P802.1Qcz / D1.0 WG Ballot Report

First WG ballot stats

Material for discussion of comments 30 and 35

Proposed Solution

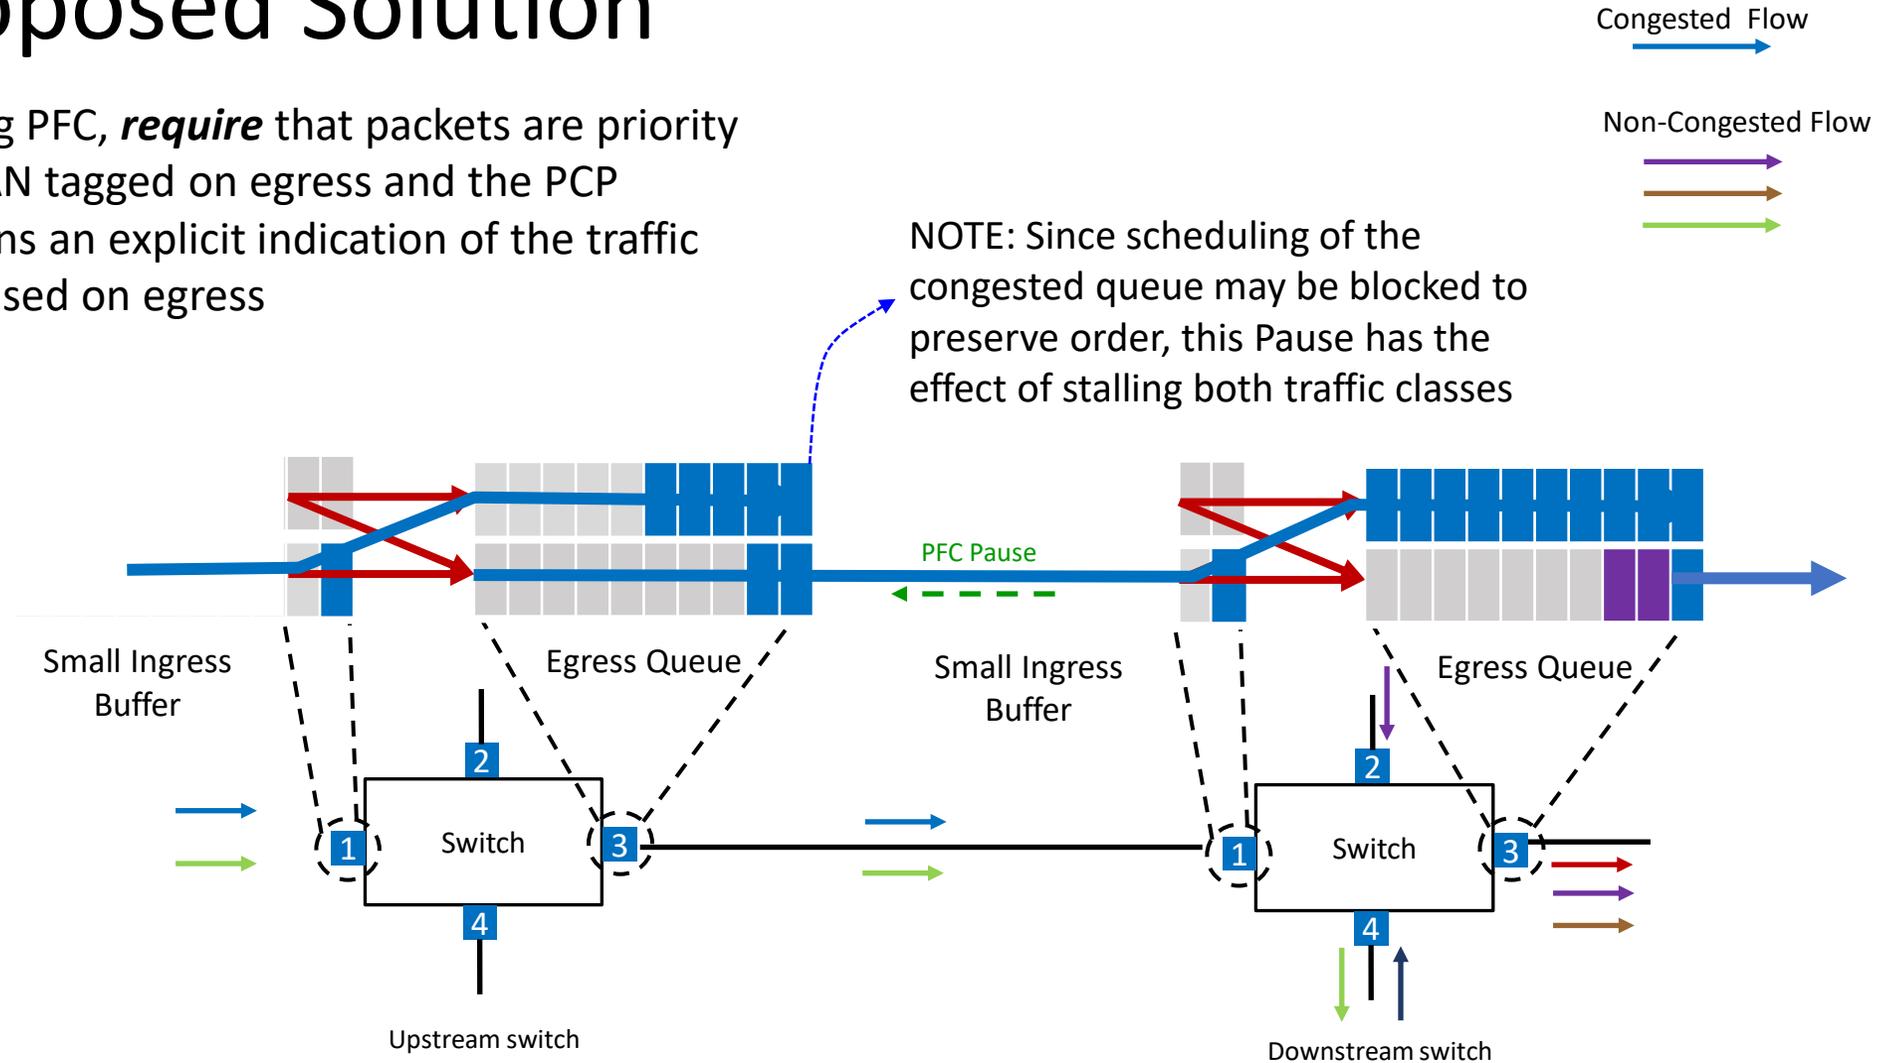
- Previous discussion of the complexity of interacting with PFC had assumed the downstream switch can not identify the traffic class used upstream to egress the packet.
- As long as the downstream switch 'knows' what traffic class the upstream switch egressed the packet, the downstream switch can Pause the correct traffic class

If using PFC, **require** that packets are priority or VLAN tagged on egress and the PCP contains an explicit indication of the traffic class used on egress

NOTE: Since scheduling of the congested queue may be blocked to preserve order, this Pause has the effect of stalling both traffic classes

Congesting Flow Stickiness

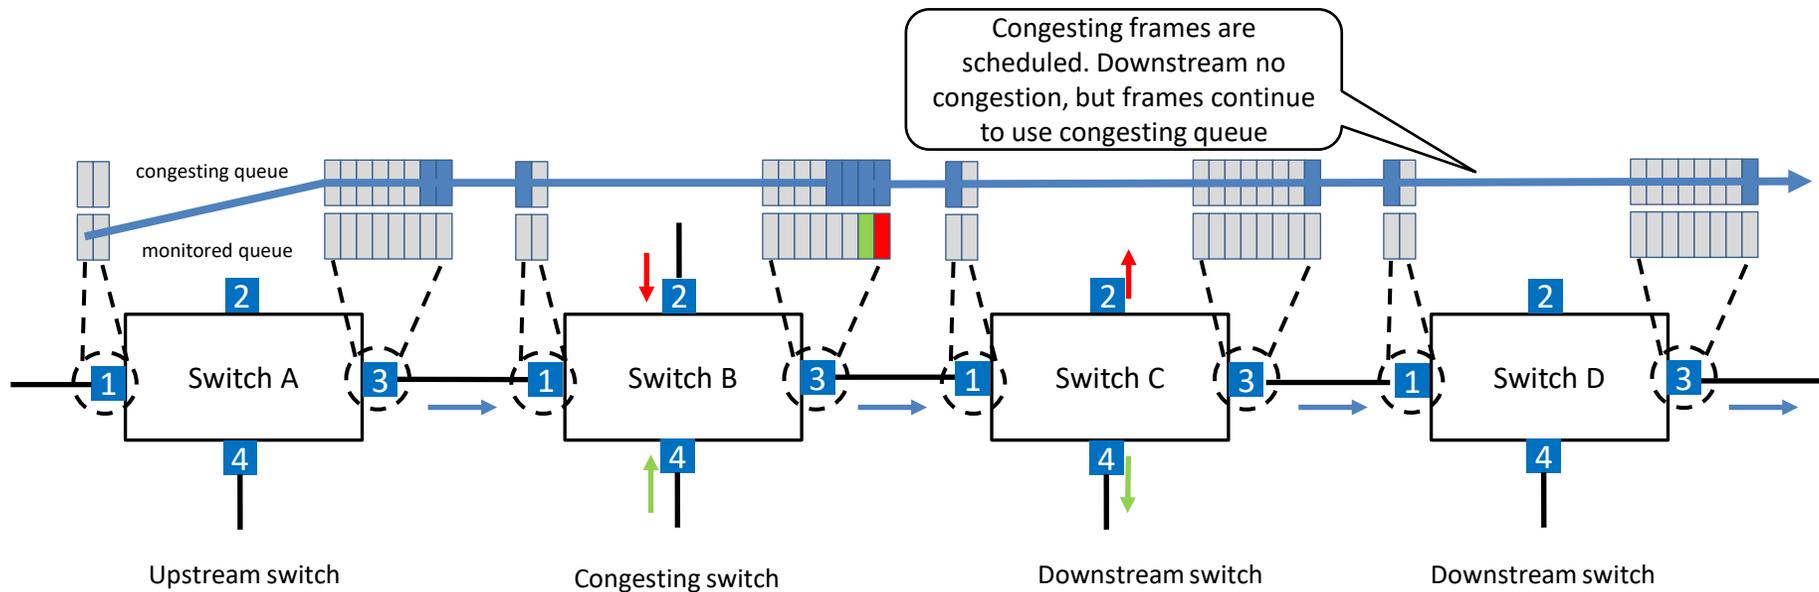
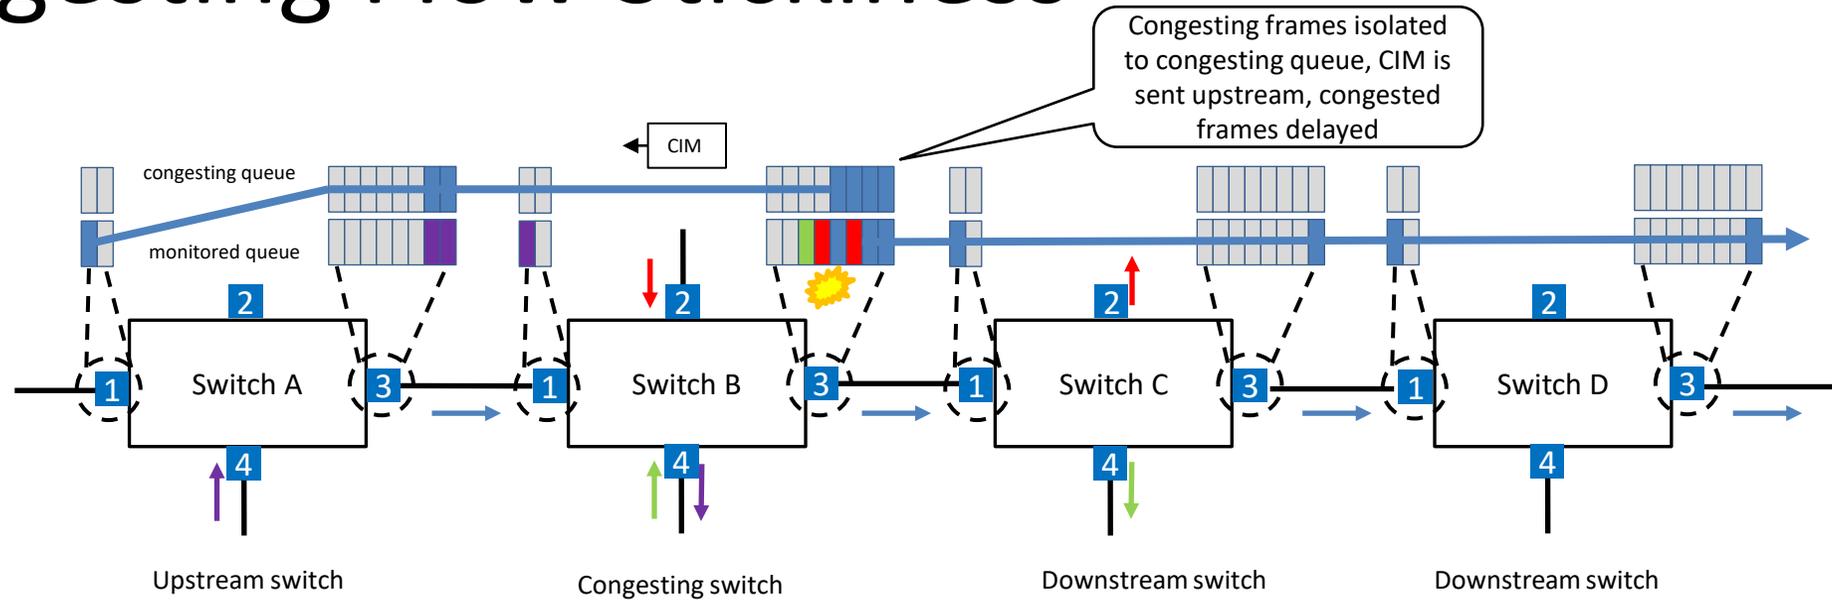
- Essence of the comments: Why are we changing the PCP on frames that are having their priority remapped?
- Material taken from previous contributions:
 - [cz-congdon-ci-design-topics-1118-v01](#)
 - [cz-congdon-d0-4-status-1119-v02](#)

- Downstream switches should change the priority of these frames back to use the monitored queue.
 - We need a stream filter to match these frames
- Downstream switches do NOT have an entry in the stream identity table for these streams
 - Entries are created by detecting local congestion – not present downstream
 - Entries are created by receipt of CIM – not sent downstream
- We need a new stream_handle specification to match the absence of a stream_handle
